Attachment 1- Answers and Clarification Document

Bidders' Questions:

BERMUDA POWER
 DISTRIBUTION CENTERS
 NAME OF JOB
 AND LOCATION

DATE 5/24/2022
 DATE
 DWG. NO. 52161 - 1B

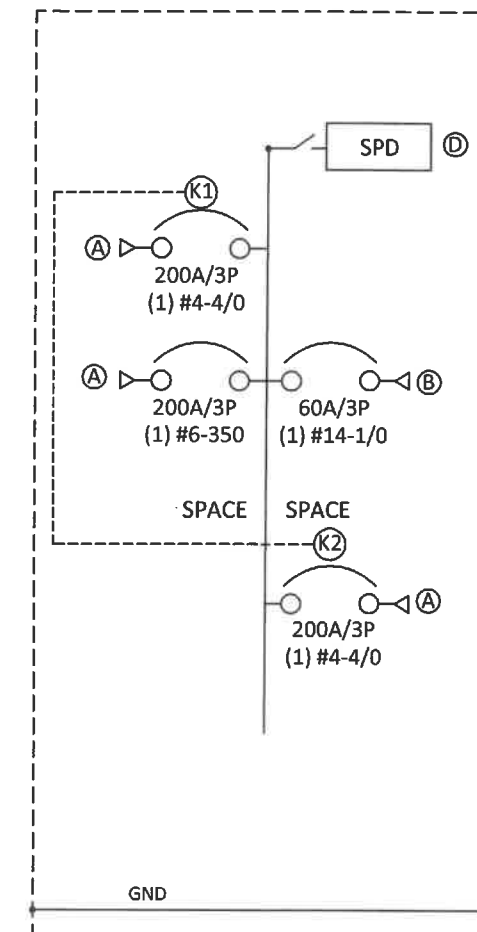
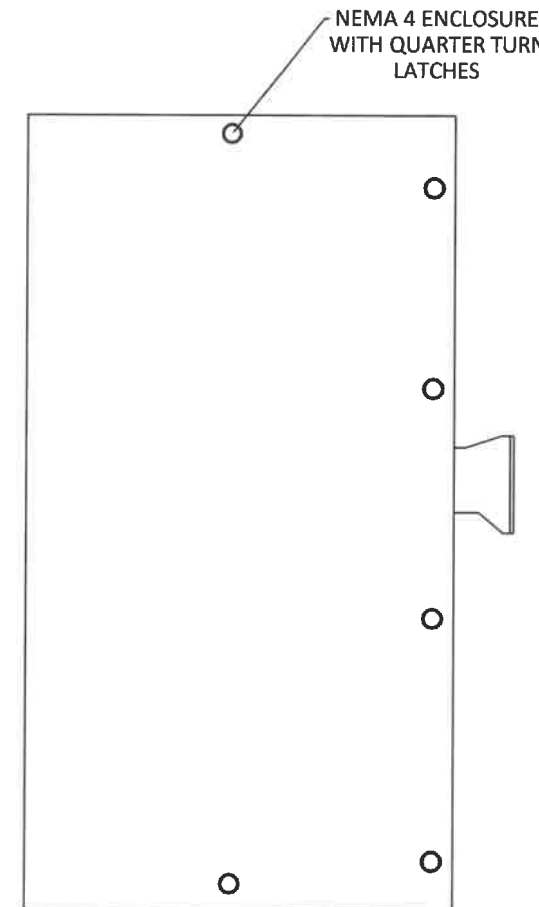
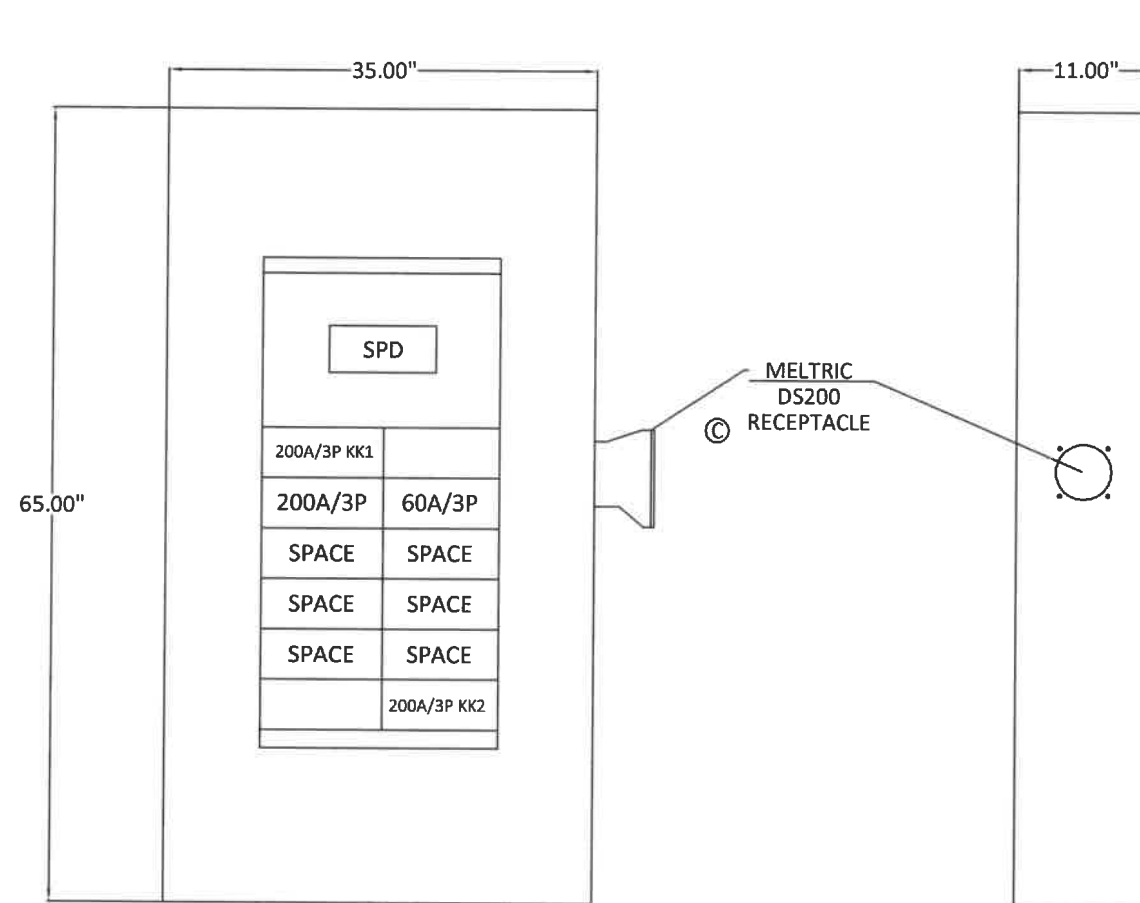
4. Do you have cutsheet for the MLS-CP and the PDS units?
MLS Data are shown on Drawings E 6302 to E-6311 plans. I have attached a copy of the Cutsheet for MLS-CP and PDS (refer to attached Appendix A).
